**Northland Power Solar Empire L.P., Northland Power Solar Martin's Meadows L.P.,  
Northland Power Solar Abitibi L.P., Northland Power Solar Long Lake L.P.**  
**Exhibit H**  
**Tab 1**  
**Schedule 2**

# System Impact Assessment Report

**Northland Power Solar Martin's  
Meadows, Abitibi and Empire**

***CAA ID 2010-403, 2010-406, 2010-409***

**Figure 10: VAR Response Time of Minimum Acceptable Hydroelectric Facility**

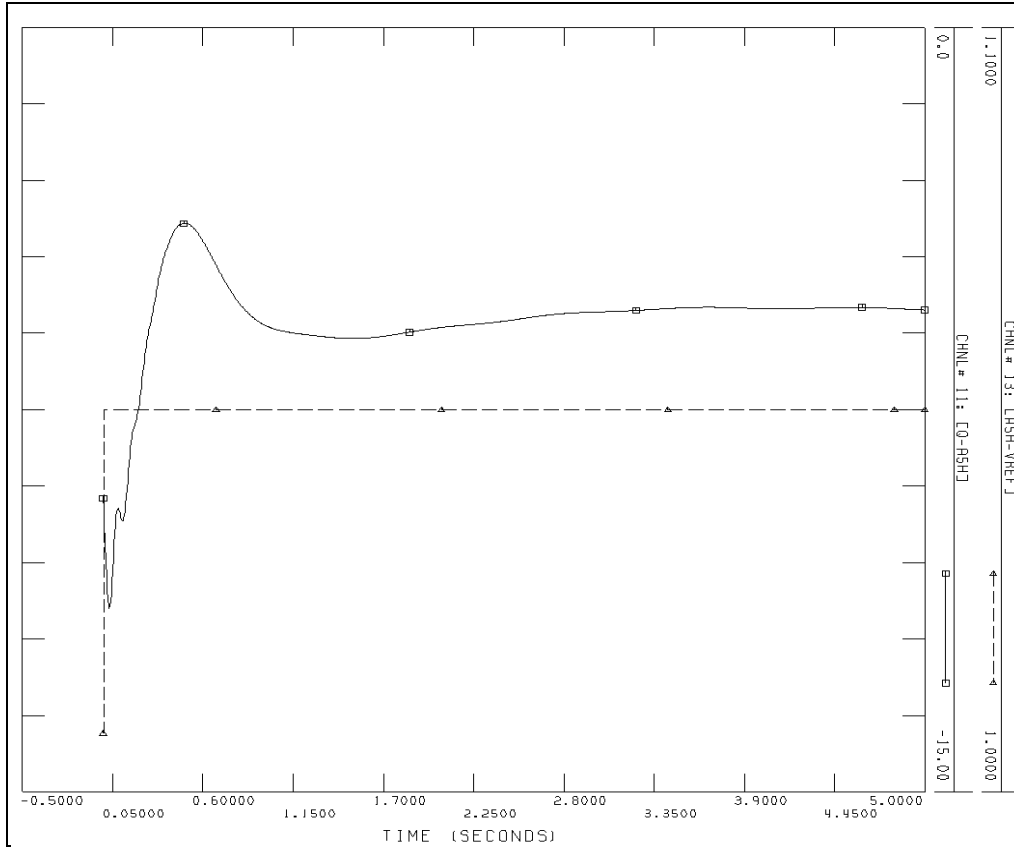
The response time of inverter var output to changes in AVR reference voltages must be minimal and similar to conventional generator technologies. Simulations using minimum acceptable default parameters of a hydroelectric facility in place of the PV inverters yielded a var response time of approximately 0.55 sec. The connection applicant is required to have similar or better var response time performance.

**Figure 11: Local Area Generator Angles for P13T @ Porcupine L-L-G Fault**

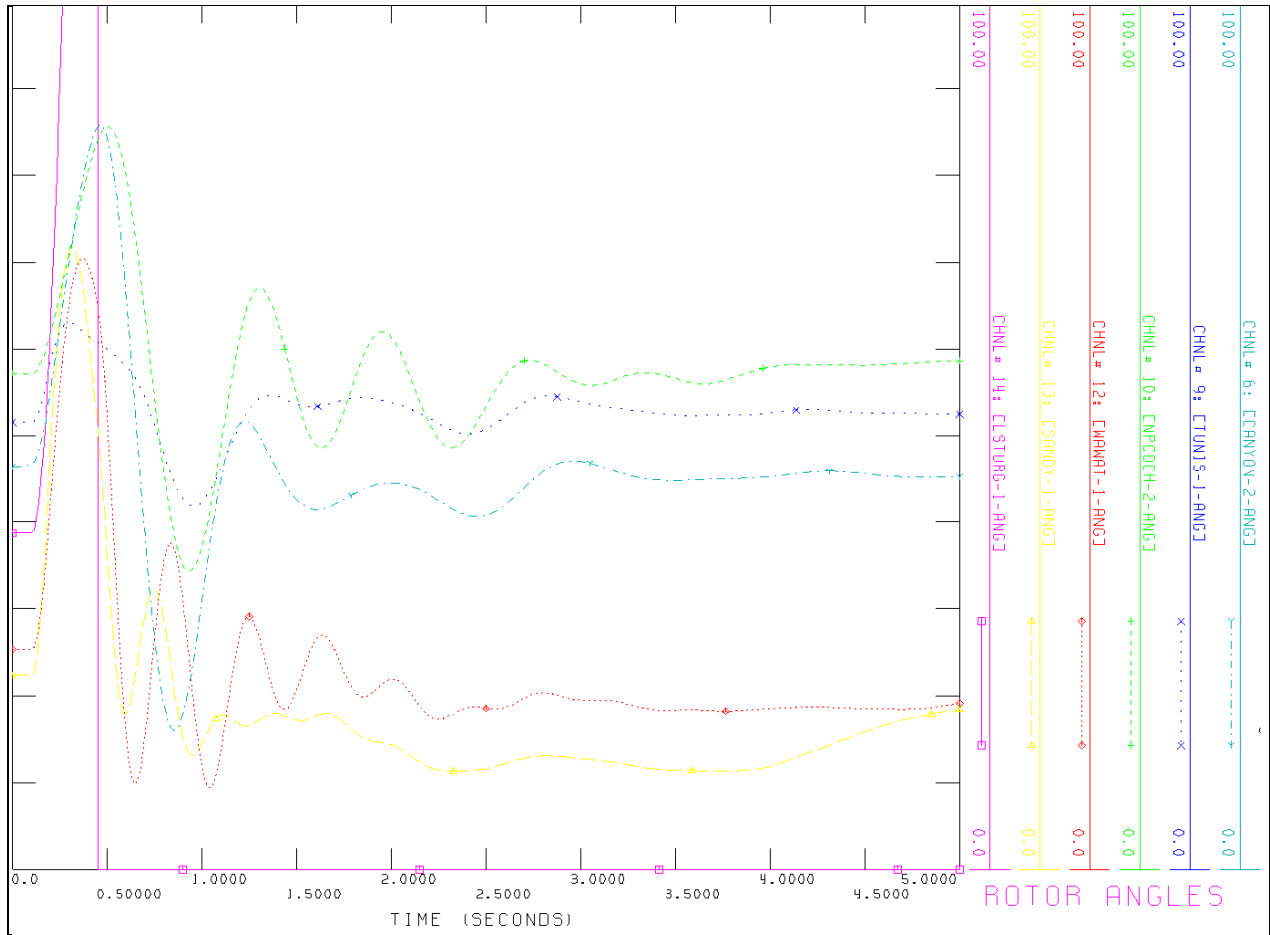
Transient simulations for the P13T @ Porcupine contingency resulted in the transient instability of the Lower Sturgeon generators. Due to the small size of these embedded units and the fact their instability does not propagate to the rest of the system, this does not pose any reliability concerns to the IESO controlled grid. Plots of all local generator angles during this fault are shown in Figure 11. Lower Sturgeon units are tripped when their rotor angles reach approximately 360 degrees to simulate their generator out-of-step protections. All other units remain stable and show well-damped angle oscillations.

**Figure 13: D3K @ Kirkland Lake 'A' & 'B' protections for 3 phase fault at Hanmer on P502X**

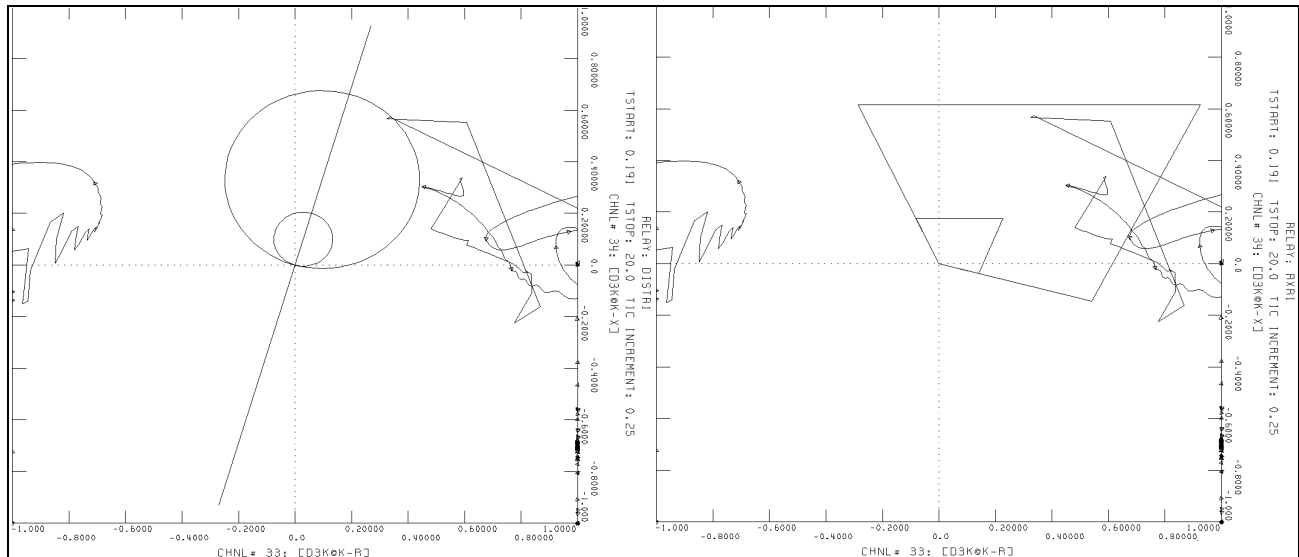
It can be seen that the trajectory for the Kirkland Lake terminal of D3K enters the 'A' and 'B' protections, zone 2 characteristics. While 'A' protections incursions were minimal, 'B' protections incursions would enter the zone 2 characteristic for approximately 350 ms, resulting in the violations of the IESO relay margin criteria. This result is consistent with conclusions and requirements made in various system impact studies completed for the incorporation of Nobel SS (CAA ID 2004-160), Lower Mattagami Expansion (CAA ID 2006-239), Porcupine and Kirkland Lake SVC (CAA ID 2006-223).

Figure 14: Terminal Voltage of SC500 Inverter During Various Simulated Faults

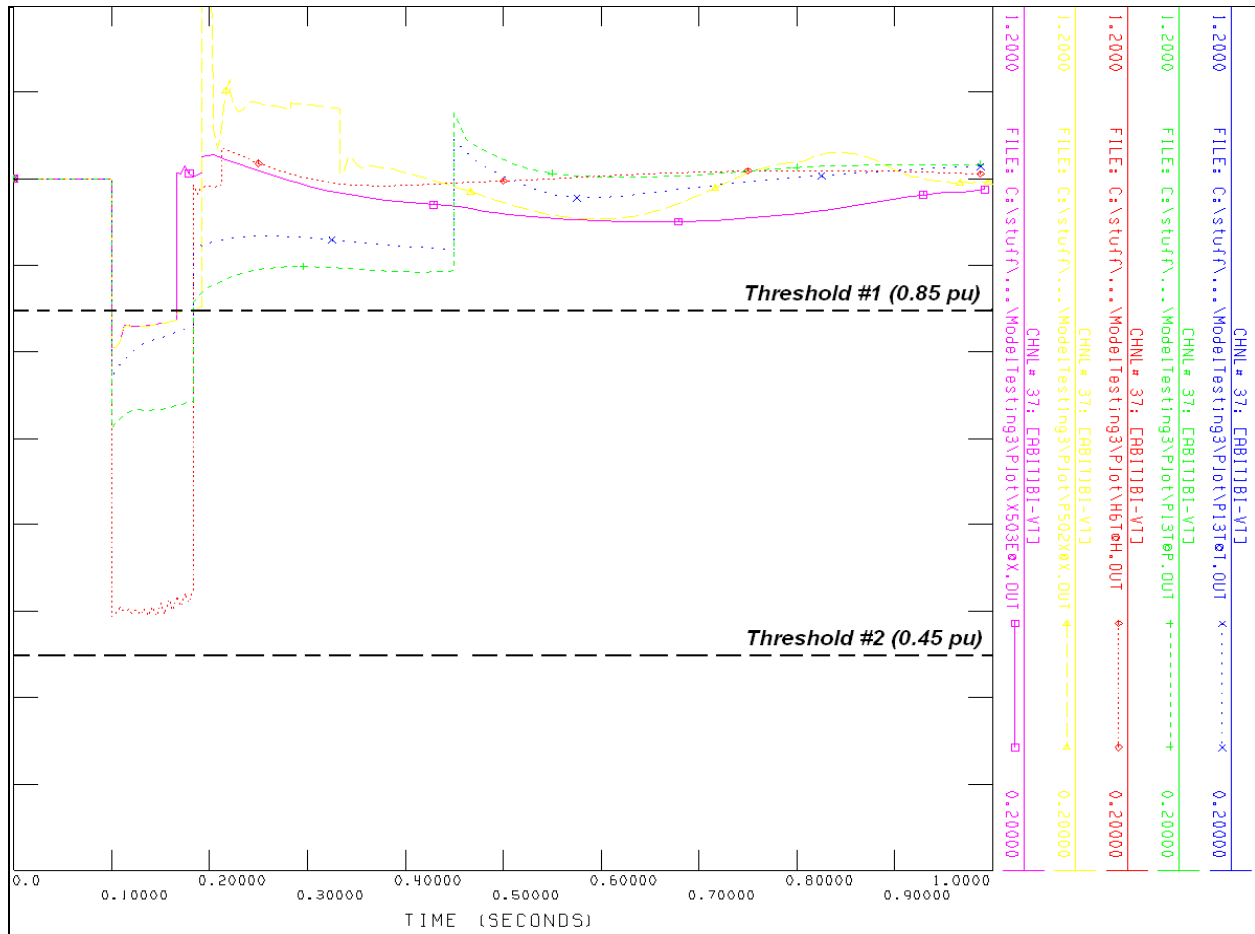
In order to examine the need for low voltage ride through (LVRT) capability, the terminal voltages of the PV inverters was monitored for the contingencies outlined in Table 13 of Section 6.7. The variation of the terminal voltage of the new generation facility is plotted in Figure 14. It can be seen that the duration during which the PV inverter terminal voltage drops below 0.85 pu is about 0.1 sec and that the terminal voltage never drops below 0.45 pu. Therefore, fault ride through capability of the proposed inverters is adequate.

The LVRT capability must be demonstrated during commissioning by monitoring several variables under a set of IESO specified field tests and the results should be verifiable using the PSS/E model.

**Figure 11: Local Area Generator Angles for P13T @ Porcupine L-L-G Fault**

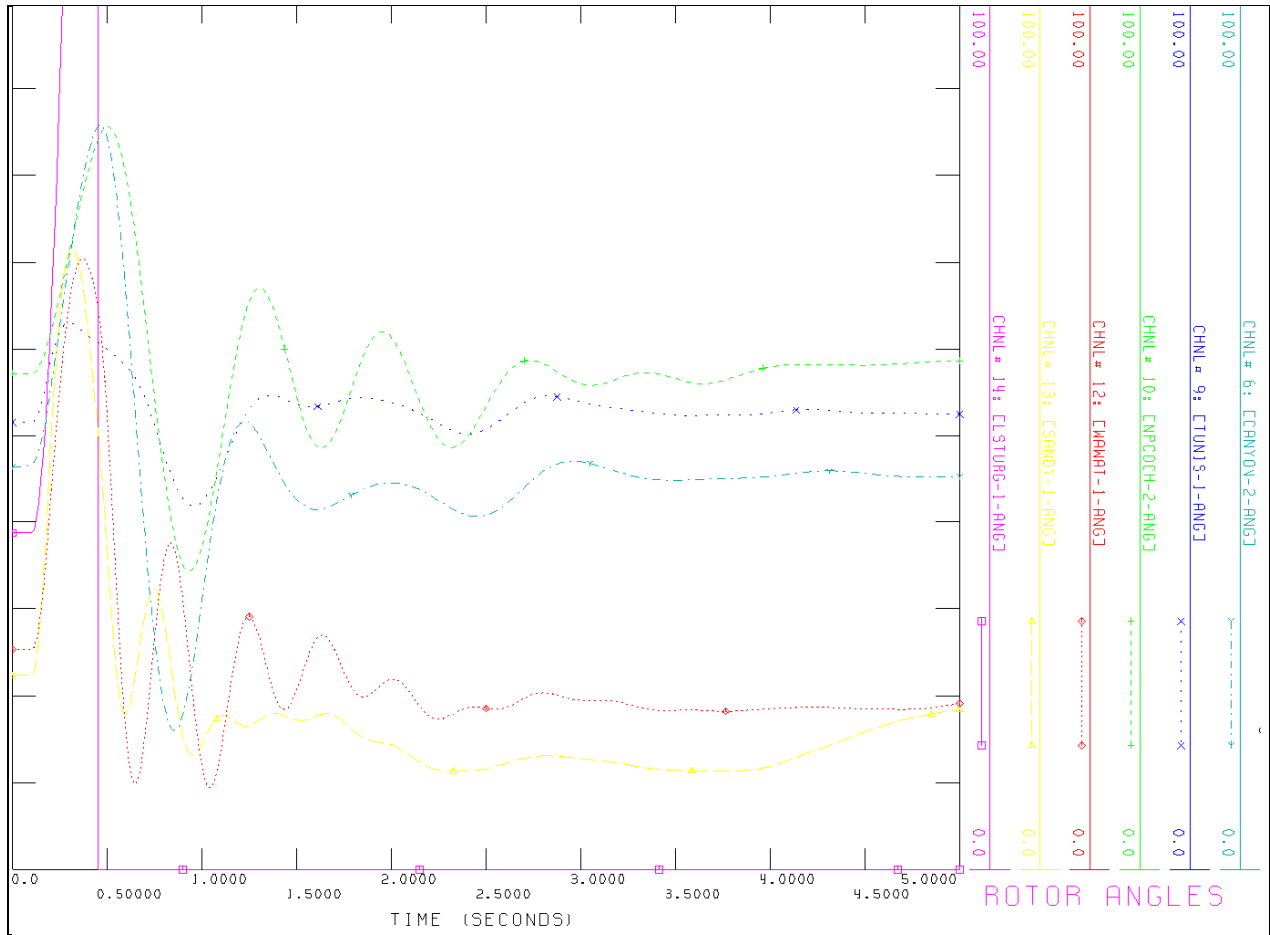
Transient simulations for the P13T @ Porcupine contingency resulted in the transient instability of the Lower Sturgeon generators. Due to the small size of these embedded units and the fact their instability does not propagate to the rest of the system, this does not pose any reliability concerns to the IESO controlled grid. Plots of all local generator angles during this fault are shown in Figure 11. Lower Sturgeon units are tripped when their rotor angles reach approximately 360 degrees to simulate their generator out-of-step protections. All other units remain stable and show well-damped angle oscillations.

**Figure 13: D3K @ Kirkland Lake 'A' & 'B' protections for 3 phase fault at Hanmer on P502X**

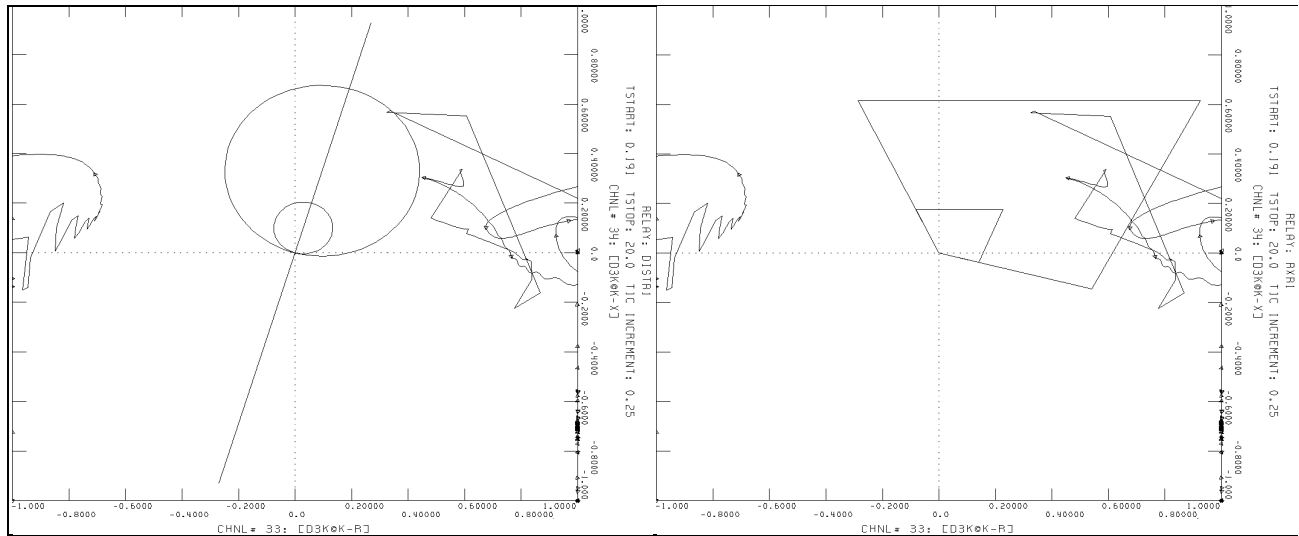
It can be seen that the trajectory for the Kirkland Lake terminal of D3K enters the 'A' and 'B' protections, zone 2 characteristics. While 'A' protections incursions were minimal, 'B' protections incursions would enter the zone 2 characteristic for approximately 350 ms, resulting in the violations of the IESO relay margin criteria. This result is consistent with conclusions and requirements made in various system impact studies completed for the incorporation of Nobel SS (CAA ID 2004-160), Lower Mattagami Expansion (CAA ID 2006-239), Porcupine and Kirkland Lake SVC (CAA ID 2006-223).

**Figure 14: Terminal Voltage of SC500 Inverter During Various Simulated Faults**

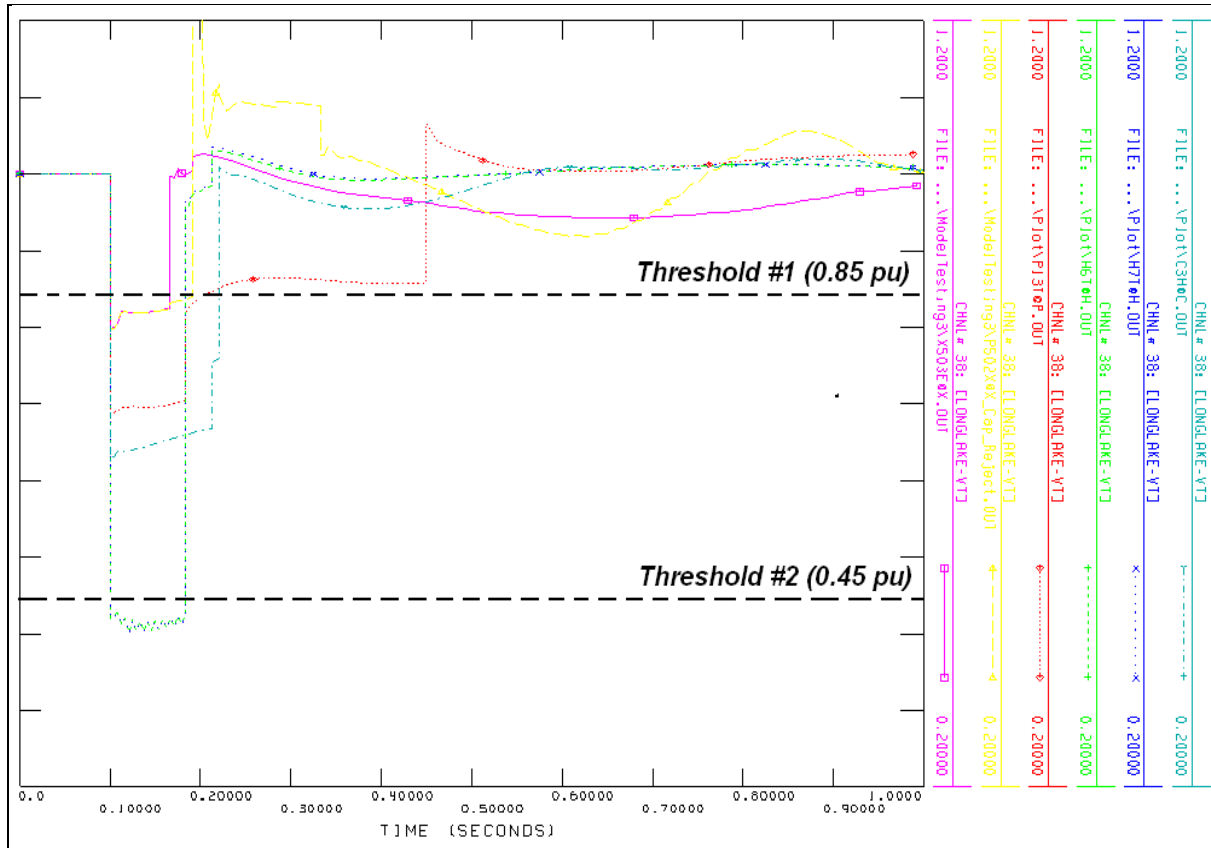
In order to examine the need for low voltage ride through (LVRT) capability, the terminal voltages of the PV inverters was monitored for the contingencies outlined in Table 13 of Section 6.7. The variation of the terminal voltage of the new generation facility is plotted in Figure 14. It can be seen that the PV inverter terminal voltage drops as low as 0.4 pu for faults at Hunta, but for a duration of less than 0.1 sec. Therefore, the fault ride through capability of the proposed inverters is adequate.

The LVRT capability must be demonstrated during commissioning by monitoring several variables under a set of IESO specified field tests and the results should be verifiable using the PSS/E model.
